# WATERSIDE AT LAKE WOODMOOR

## SW 1/4 OF THE SE 1/4 OF SECTION 11 TOWNSHIP 11 SOUTH, RANGE 67 WEST, 6TH PRINCIPAL MERIDIAN EL PASO COUNTY, COLORADO PUD DEVELOPMENT PLAN/PRELIMINARY PLAN

# V3\_PUD Development Plan.pdf Markup Summary

**PRELIMINARY GRADING PLAN**

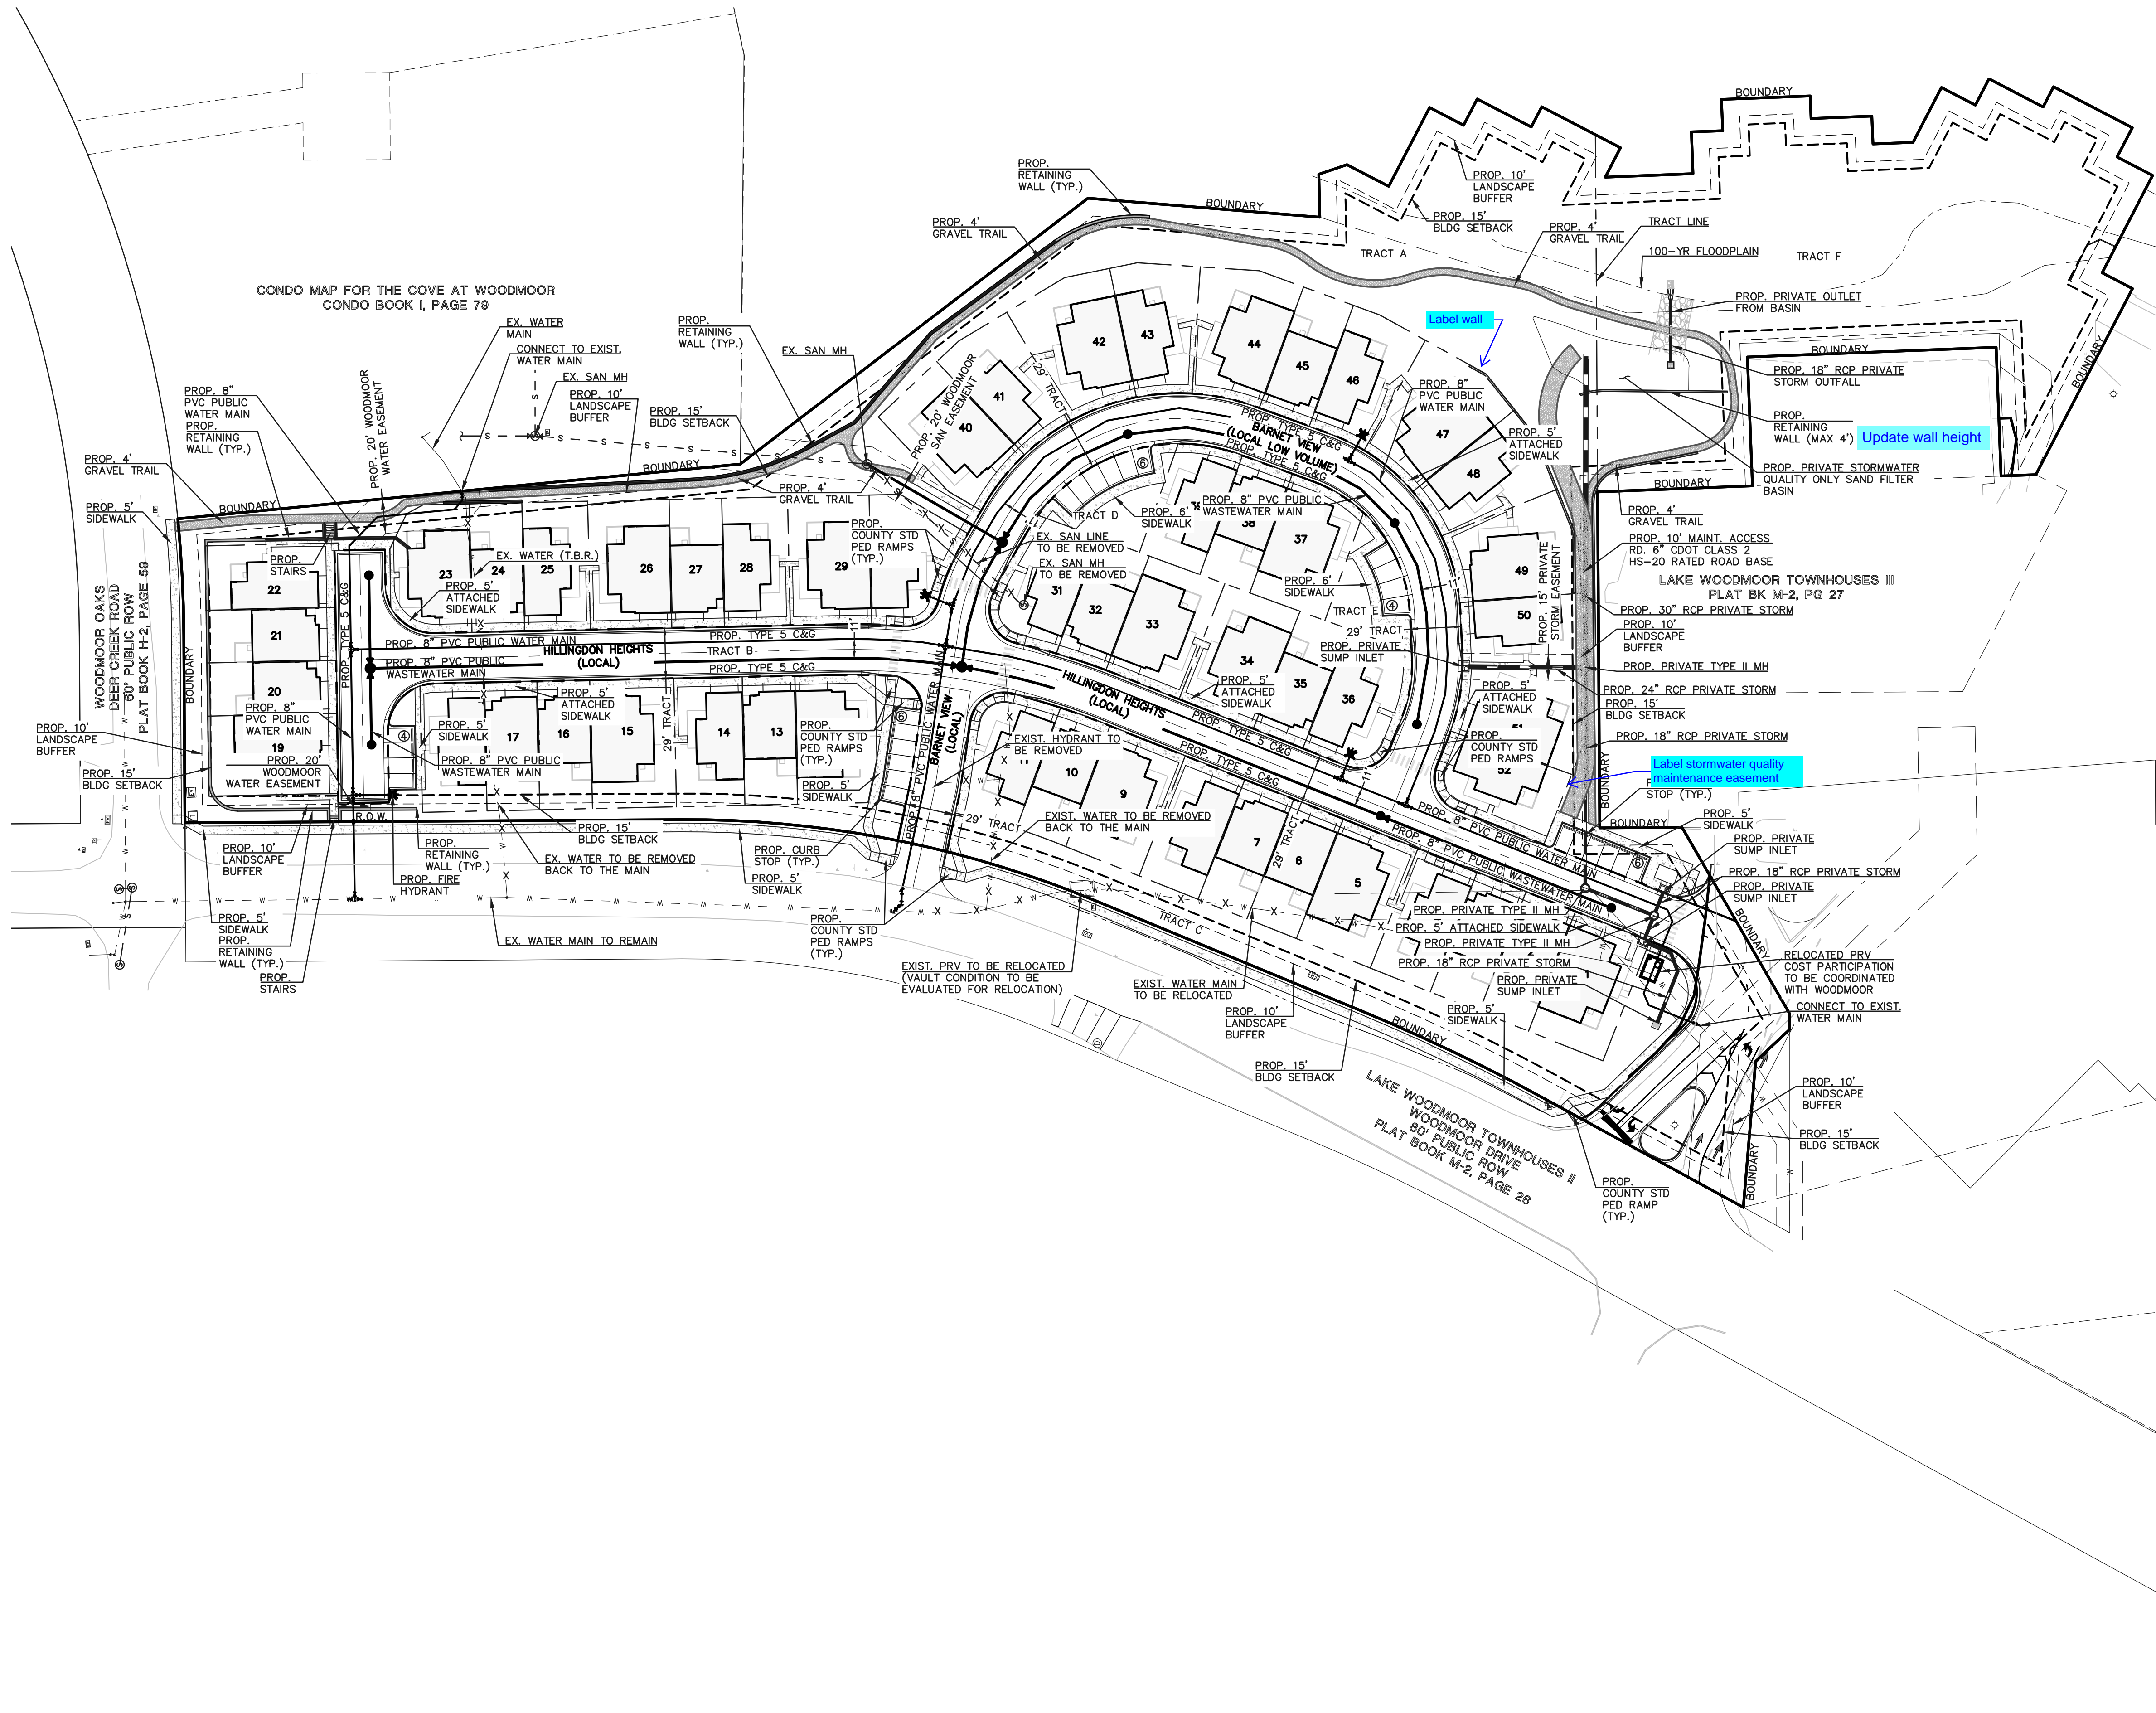
Include max height of wall

Sidewalk needs to be within a public improvement easement

Label stormwater quality maintenance easement

Label wall

Per spot elevations, wall is greater than 4'

Update wall height
